Access Compliance Report

Public Rights-of-Way

(Curb Ramps)

Intersection ID: 48196	Main Street: BLAKENEY_PARK_DR	Cross Street: REA_RD	Location:	N
ADA ID: 4142AD66B3EC	Ramp Type: Perp	Initial Pass/Fail: Fail	Overall Compliance: No	Severity Score: 8.75
Codes/Mitigation Info/Possible Solution		Field Measurements/Component Compliance

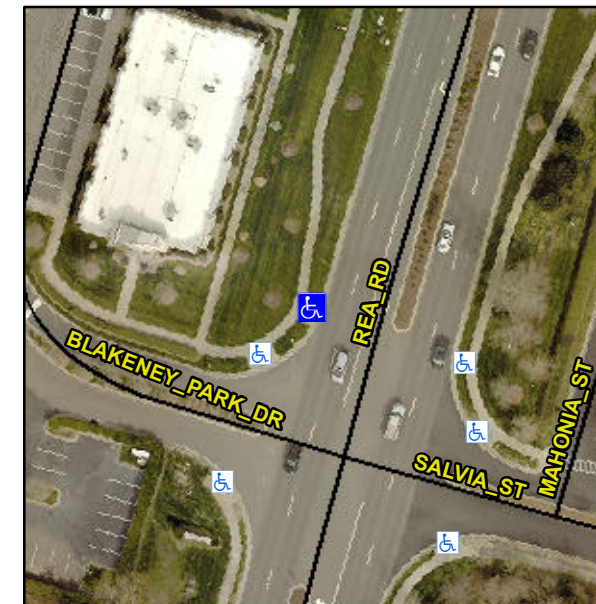
Compliance	Description	Data	Compliance	Description	Data
N/A	Ramp Length (in)	91.0	Yes	Ramp Slope (%)	6.6
No	Ramp Width (in)	46.0	Yes	Ramp XSlope (%)	0.5
N/A	Flare Type LT	N/A	N/A	Flare Type RT	N/A
N/A	Flare Slope LT (%)	N/A	N/A	Flare Slope RT (%)	N/A
N/A	Flare Traversable LT?	N/A	N/A	Flare Traversable RT?	N/A
N/A	Landing Length (in)	N/A	N/A	DWS Provided?	N/A
N/A	Landing Width (in)	N/A	N/A	DWS Contrast?	N/A
N/A	Landing Slope (%)	N/A	N/A	DWS Length (in)	N/A
N/A	Landing X Slope (%)	N/A	N/A	DWS Full Width?	N/A
N/A	Landing Curb? (Y/N)	N/A	N/A	DWS Offset (in)	N/A
N/A	Shared Landing?	N/A			
N/A	Gutter Ponding?	N/A	N/A	Gutter Slope (%)	N/A
N/A	Gutter Lip Ht (in)	N/A	N/A	Gutter X Slope (%)	N/A
N/A	Painted X Walk1?	No	N/A	Painted X Walk2?	N/A
	X Walk 1 Direction	To SE		X Walk 2 Direction	N/A
N/A	X Walk 1 Width (in)	N/A	N/A	X Walk 2 Width (in)	N/A
	X Walk 1 Slope (%)	3.1		X Walk 2 Slope (%)	N/A
	X Walk 1 X Slope (%)	0.5		X Walk 2 X Slope (%)	N/A

N/A	Ramp inside XWalk1?	N/A	N/A	Ramp inside XWalk2?	N/A
	Road Slope (%)	N/A	N/A	Clear Space?	N/A
	Road X Slope (%)	N/A	N/A	Clear Space to XWalk (in)	N/A
N/A	Any Obstructions?	N/A	N/A	Storm Grate/Utility Hazard?	N/A
	Obstruction Type			Storm Grate/Utility Type	
		N/A			N/A
			Yes	Surface Condition? (G/P)	Good

Remove & Replace Entire Ramp.

R304.5.1
